# 3C PL1 – 324 Cherry Street

Schematic Design 2

April 22<sup>nd</sup>, 2020

Review Stage: Schematic Design 2

# Facade Treatment · Detail

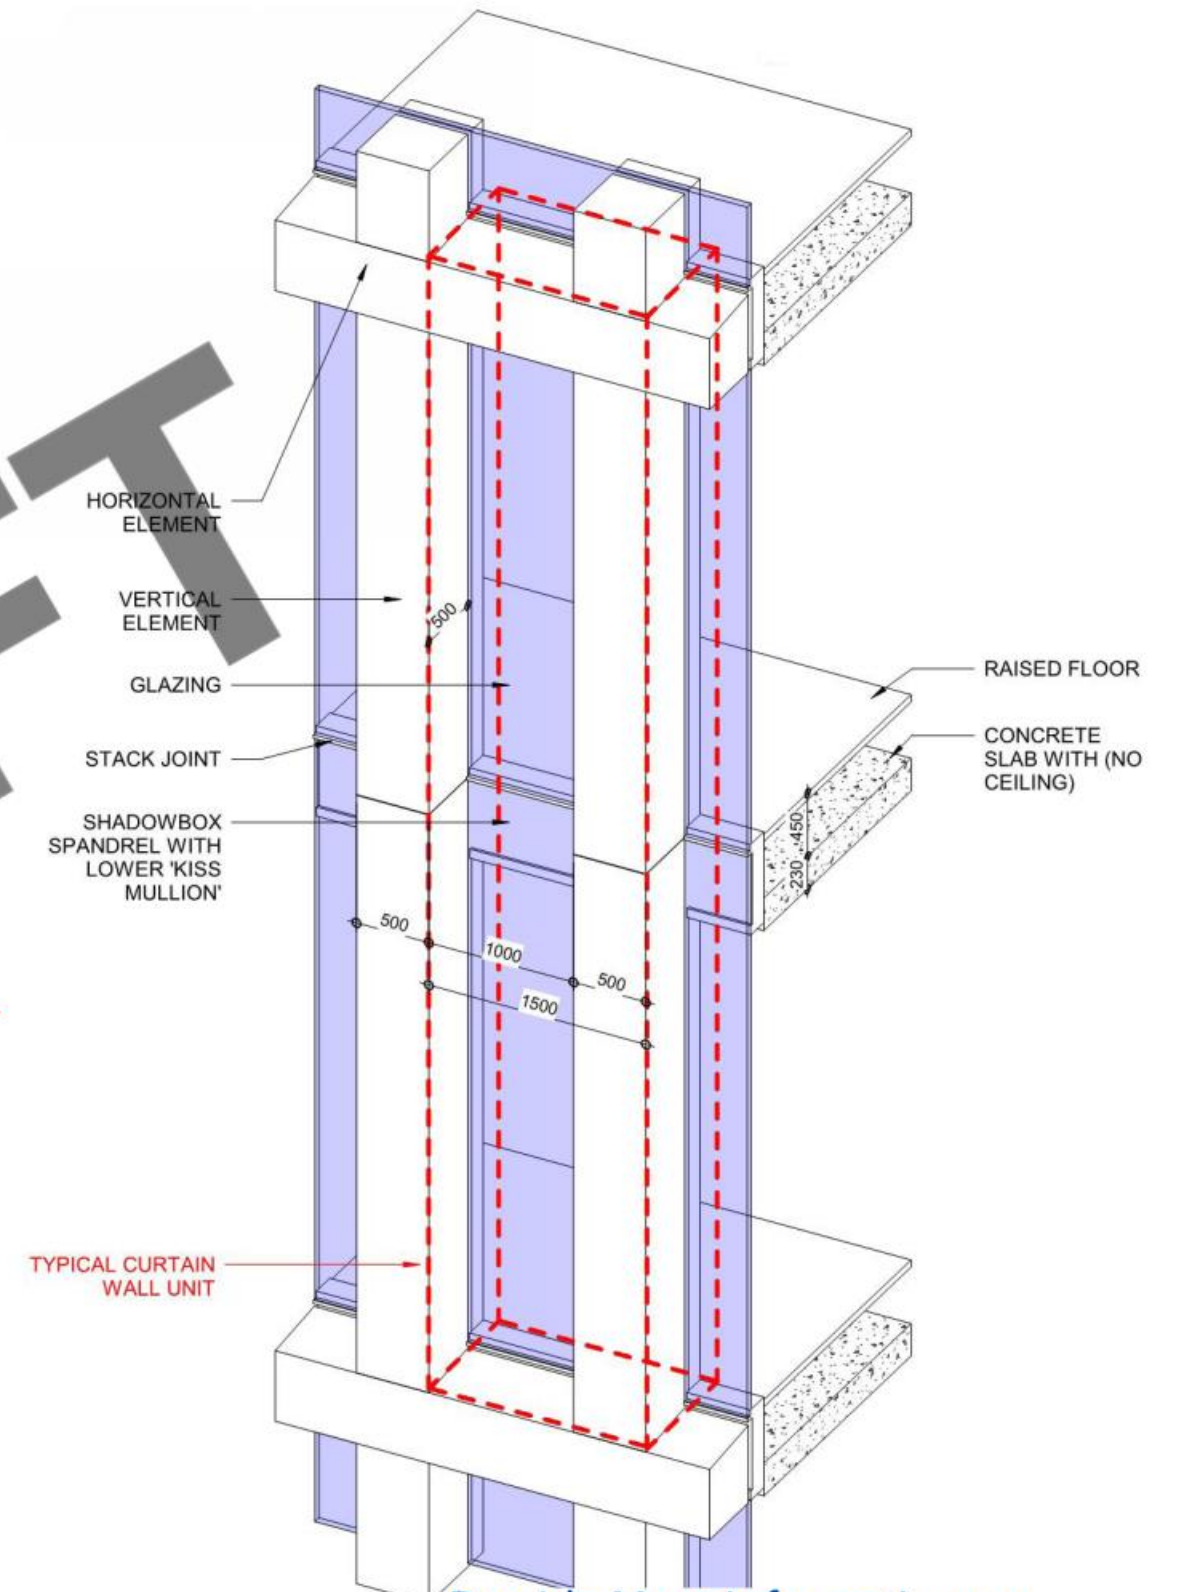
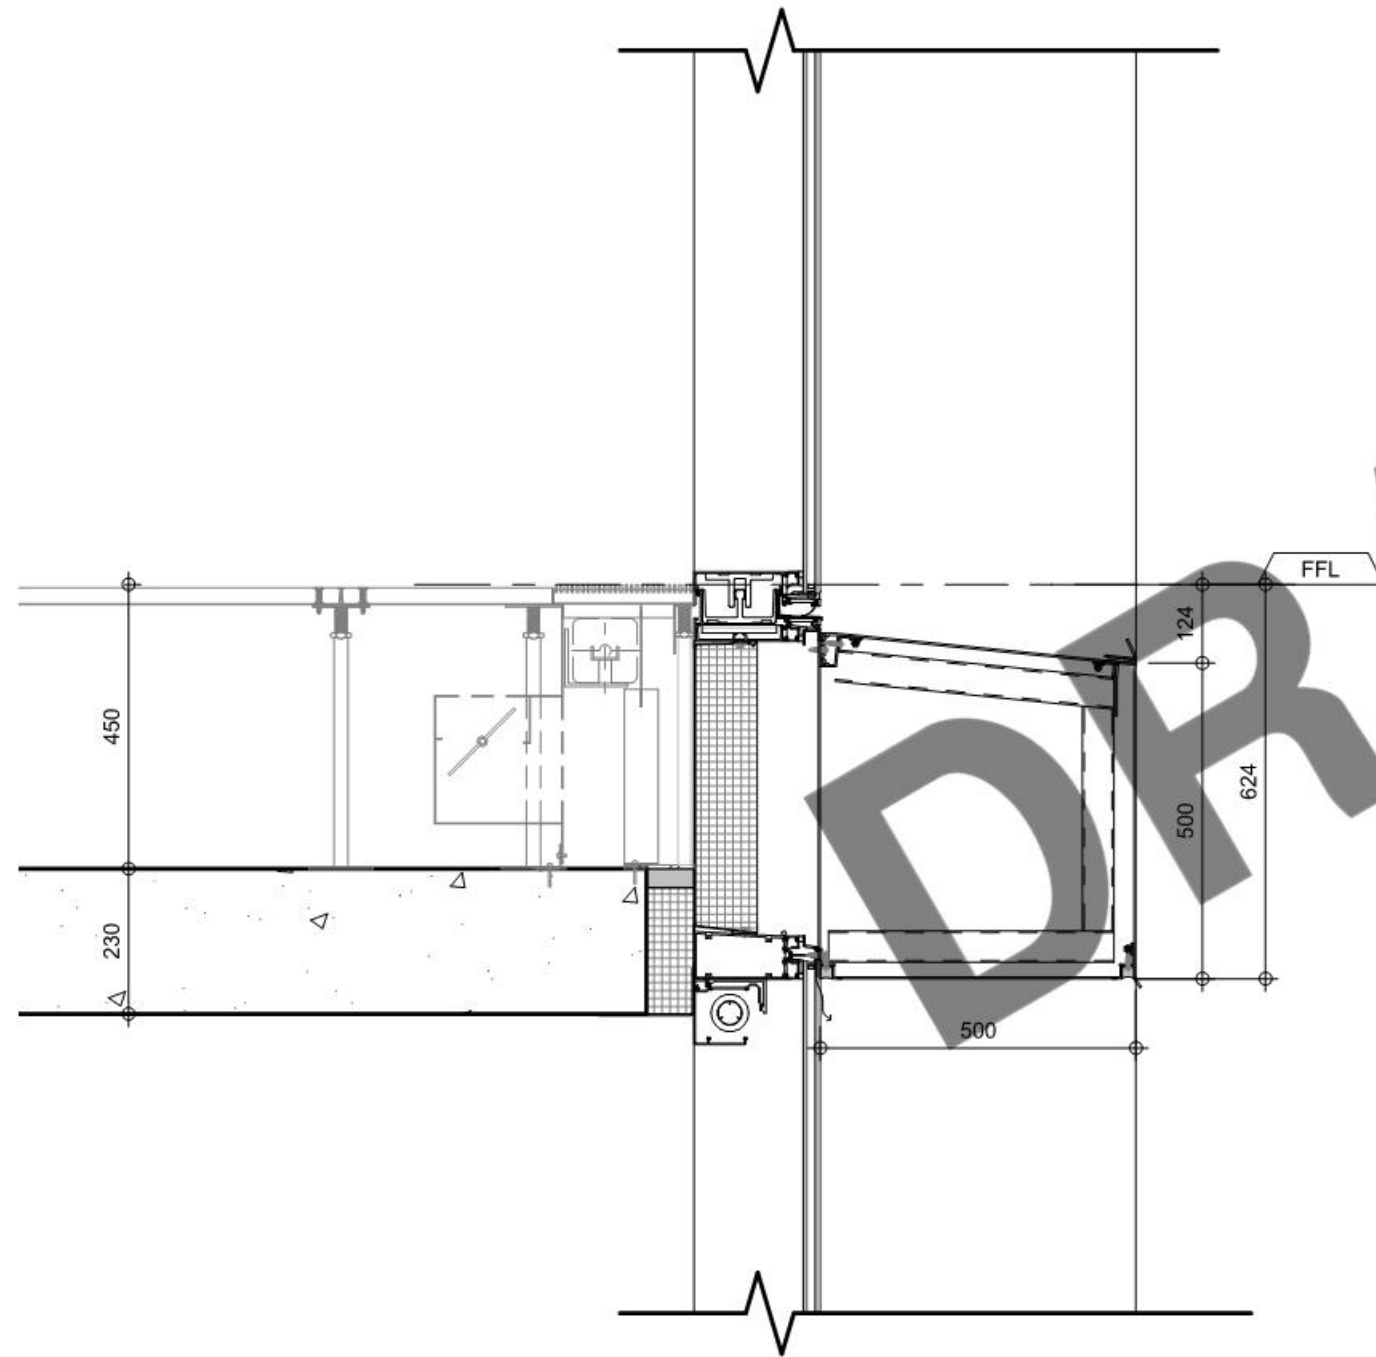
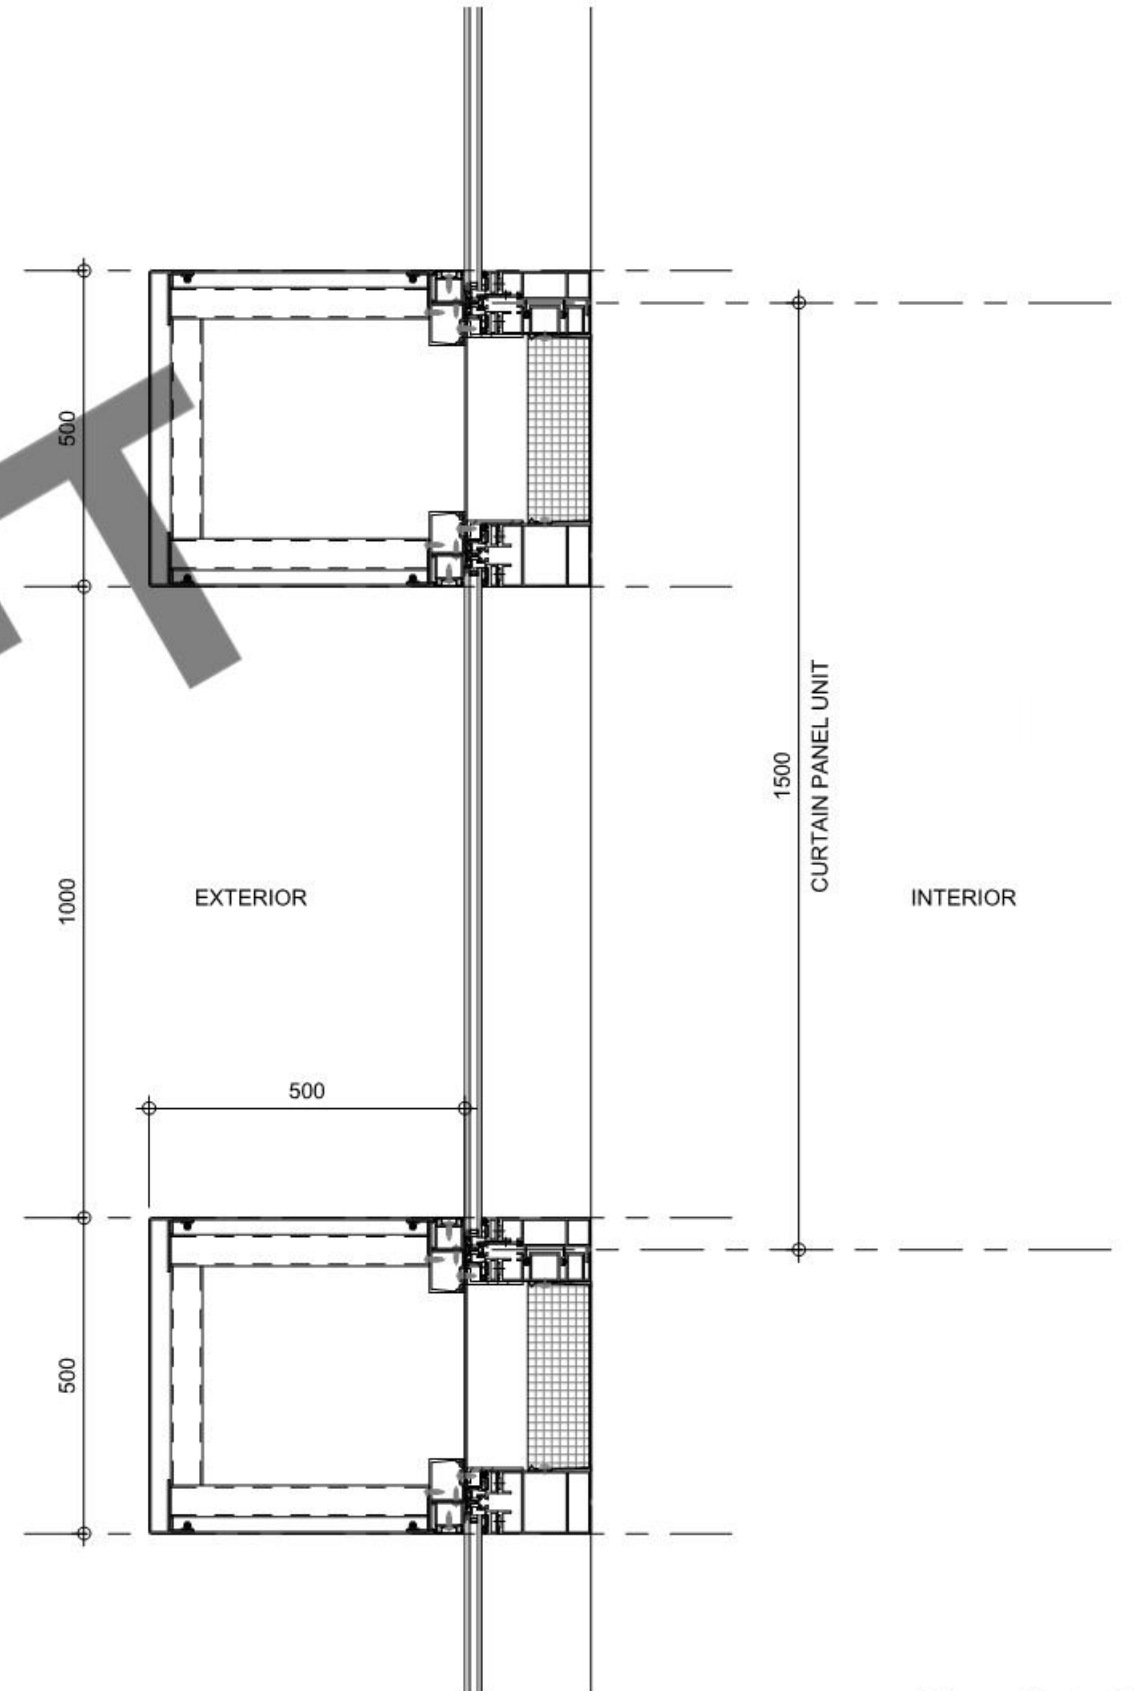
Provide More Information on Fenestration Details

- Typical facade module detail provided

South Elevation @ Entrance

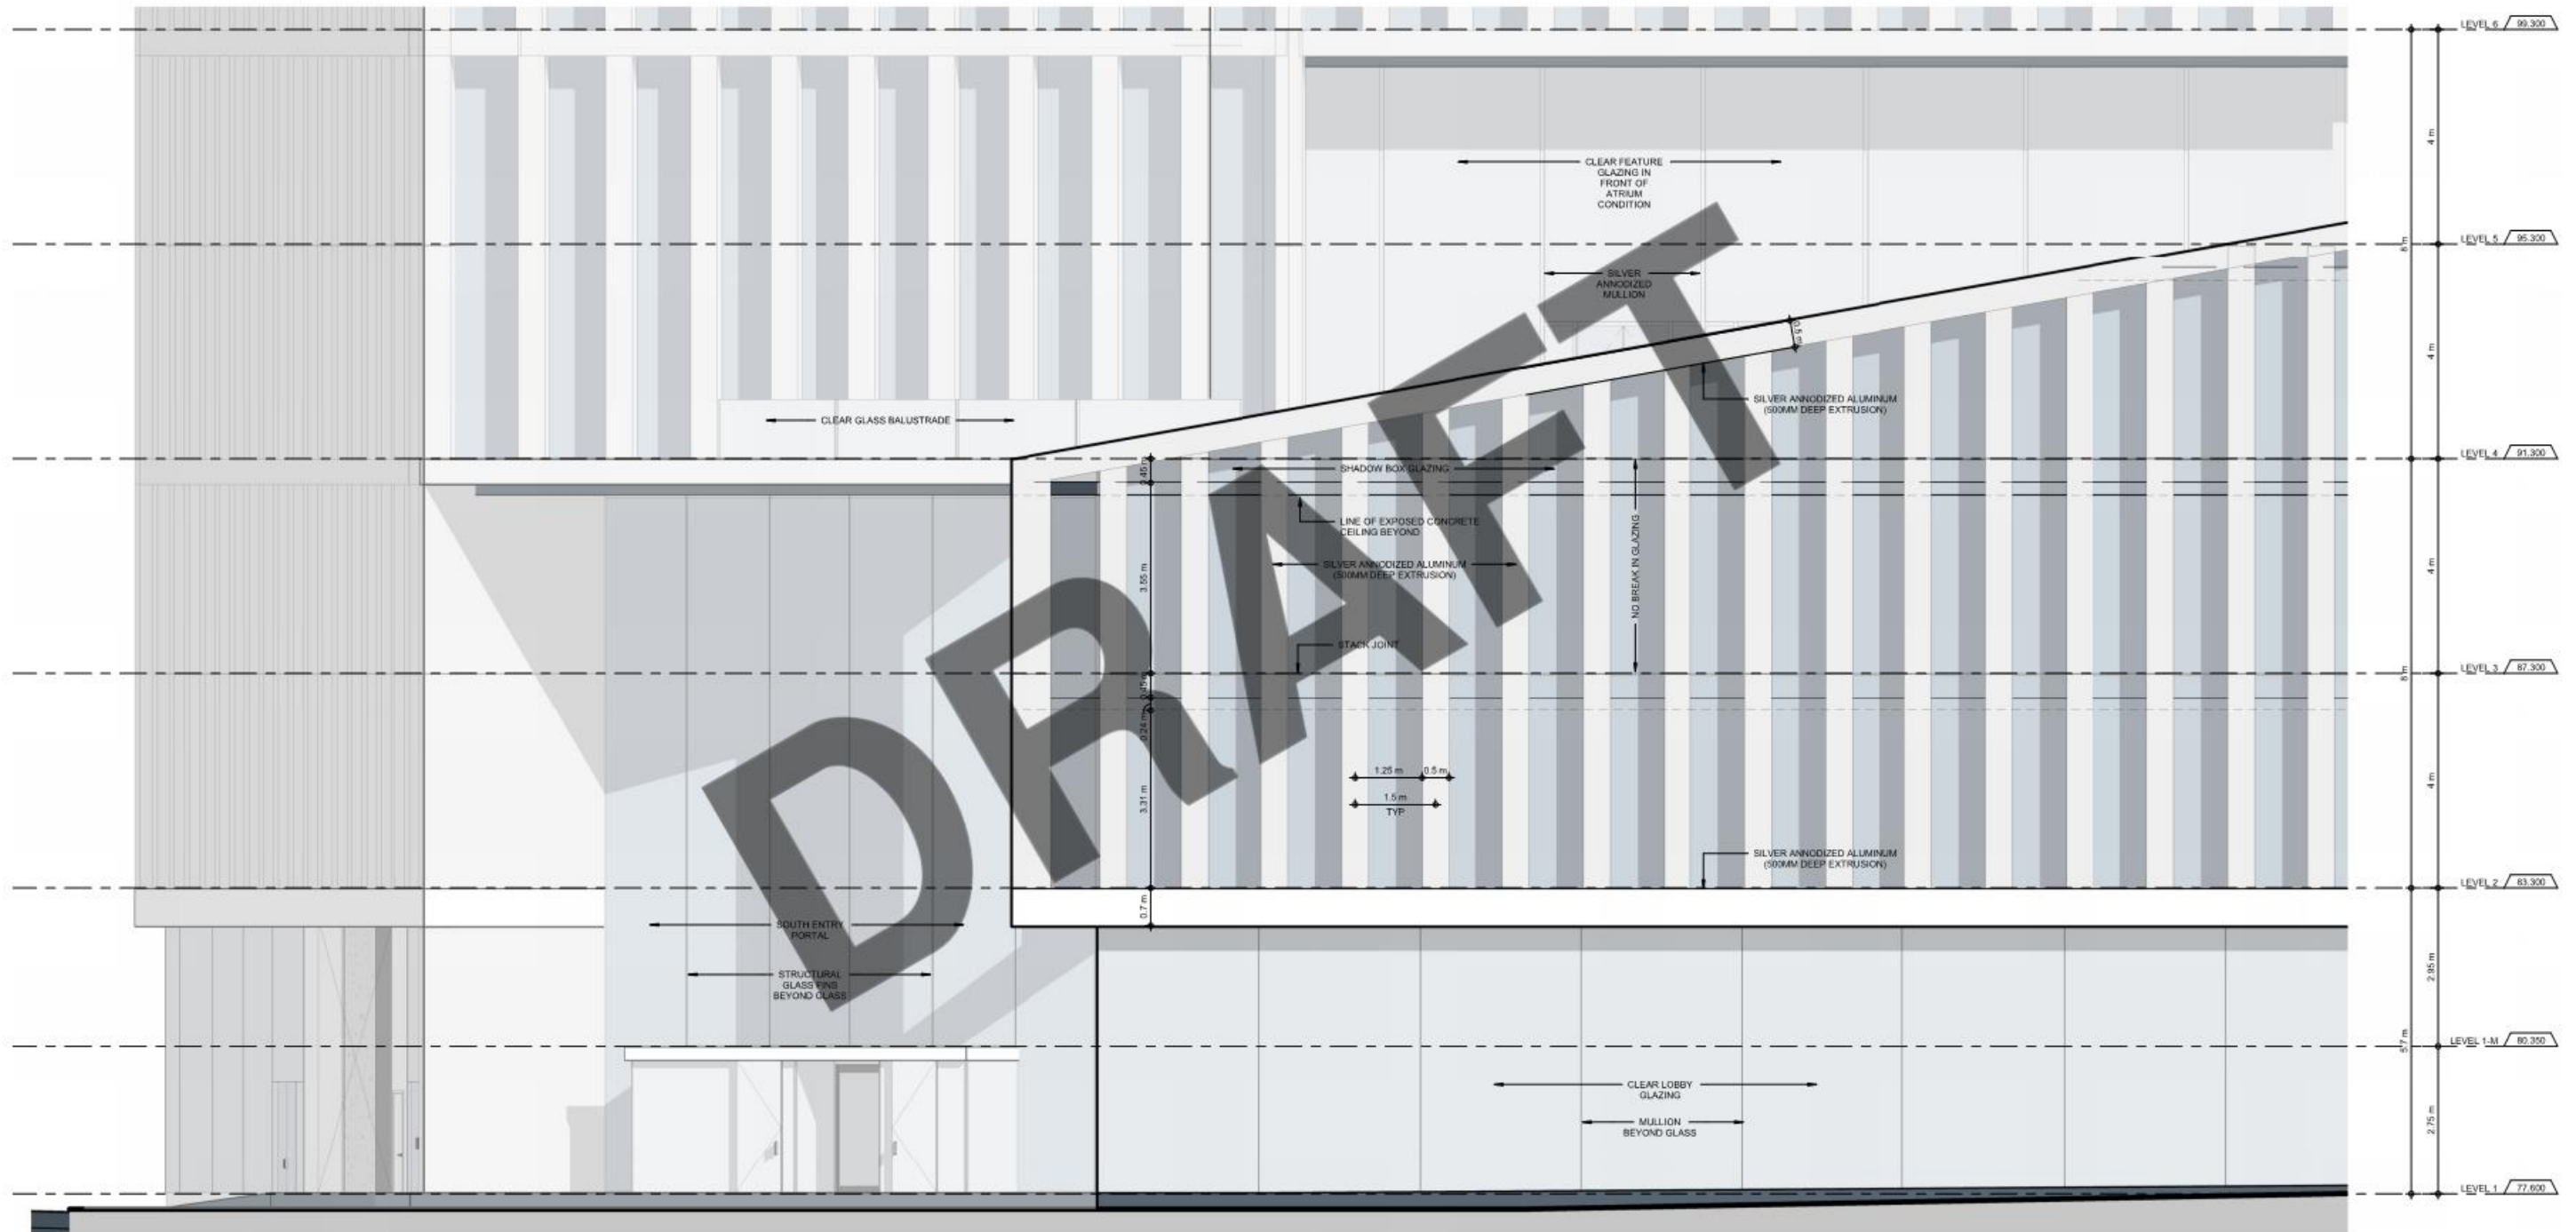
Provide detailed ground floor elevations
